REPORT OF THE PEER REVIEW PANEL  
ON THE  
PROPOSED PROGRAM OF STUDIES OF THE  
CALCITE AND OPALINE-SILICA DEPOSITS  
IN THE YUCCA MOUNTAIN AREA  
NEVADA

June 18, 1987

**PARTICIPANT REVIEW OF PEER PANEL RECOMMENDATIONS ON RESEARCH PROPOSED ON CALCITE AND OPALINE SILICA DEPOSITS LOCATED ALONG FAULTS**

### CLARIFICATION OF THE FINAL PEER REVIEW REPORT ON THE CALCITE/OPALINE SILICA DEPOSITS LOCATED ALONG FAULTS NEAR YUCCA MOUNTAIN

TABLE 1. FLOW PLAN FOR INVESTIGATIONS OF  
THE CALCITE AND OPALINE-SILICA VEINS

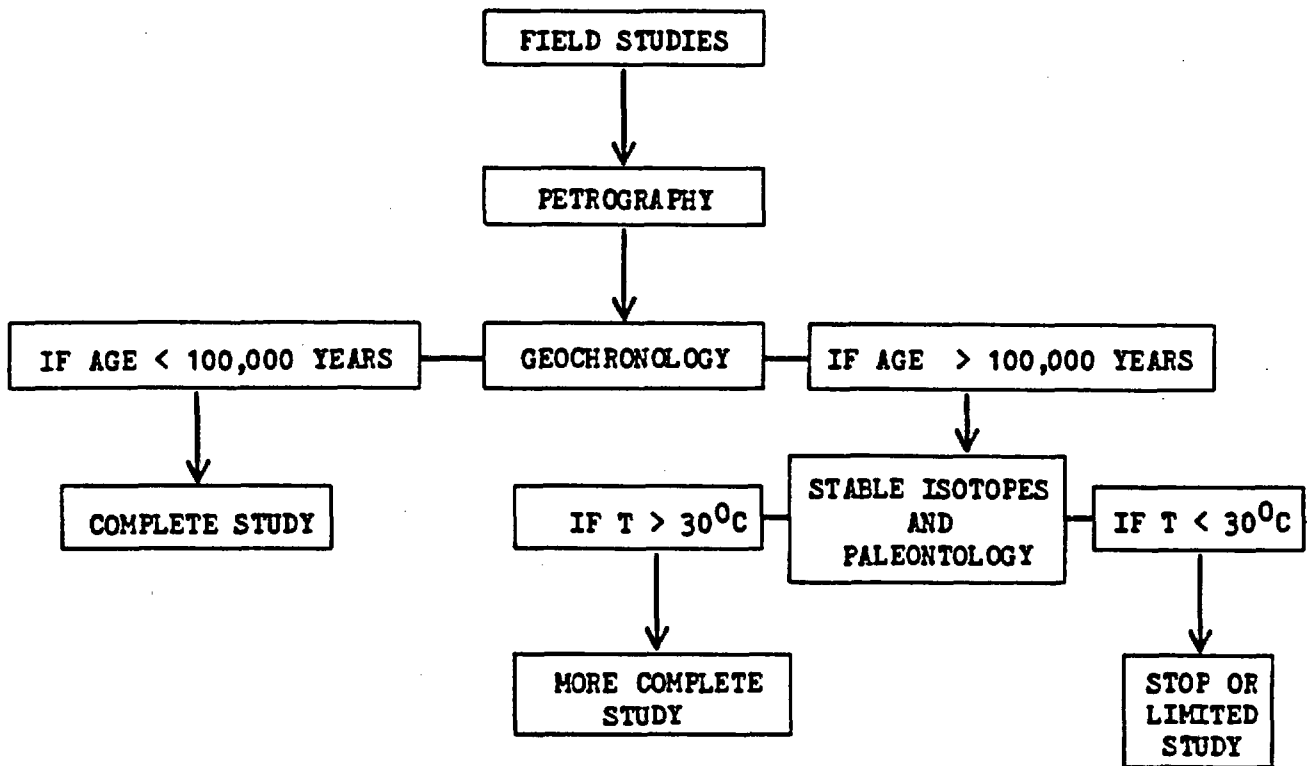
We recommend that field, petrographic, geochronological, stable isotope, and paleontological studies be undertaken at each site. Table 1 shows a plan for studies at each site. These studies are most important for: (1) helping to determine the age of the vein and breccia deposits associated with faulting; (2) placing constraints on time intervals between fault movements on a given fault assuming new veins are introduced at, or near, the time of faulting; (3) determining the temperature of waters responsible for the vein deposits; and (4) determining the origin of the veins and breccia. If the veins are young (i.e., less than 100,000 years old), a more complete study, including mineralogy; fluid inclusions; major, minor, and trace element; and tracer isotopes studies will be required. If the veins are old (i.e., greater than 100,000 years) and formed from cold waters, no further studies may be warranted. If the veins or breccias are old (i.e., greater than 100,000 years) and from hot waters, some limited mineralogical and geochemical studies may be warranted.

Introduction, Page 2-3, Paragraph 5 (Page 2) and Table 1:

The flow plan for calcite-silica investigations proposed by the peer review committee agrees reasonably well with existing investigator plans and priorities. One significant point of departure is the reviewers' choice of a 30°C temperature as a cutoff for further study of deposits older than 100,000 years. A key question in this study is whether the calcite-silica deposits formed by discharge of ground water, particularly deep groundwater, because ground water discharge could carry radionuclides from a nuclear waste repository to the accessible environment. The importance of understanding water movement is acknowledged elsewhere in the peer review, but not in the flow plan. A 30°C temperature criterion, with or without other evidence, may be insufficient to distinguish between a ground water and surface water source. Some ground water in the vicinity of Yucca Mountain is only slightly warmer than 30°C, but the surface discharge of this water would be of just as much concern as the discharge of warmer water from depth. For these reasons, the 30°C criterion should not be given preeminence in the determination of study priorities.

The flow chart on page 3 uses 30°C as a dividing point between hot and cold waters. We assume that this is only meant to symbolize the difference between cold (which usually means less than mean annual temperature; -15°C at NTS) and hot (which usually means greater than body temperature, 37°C). Furthermore the diagram seems to imply that deep seated cold springs with an age in excess of 100,000 years are not important, and we disagree with this position.
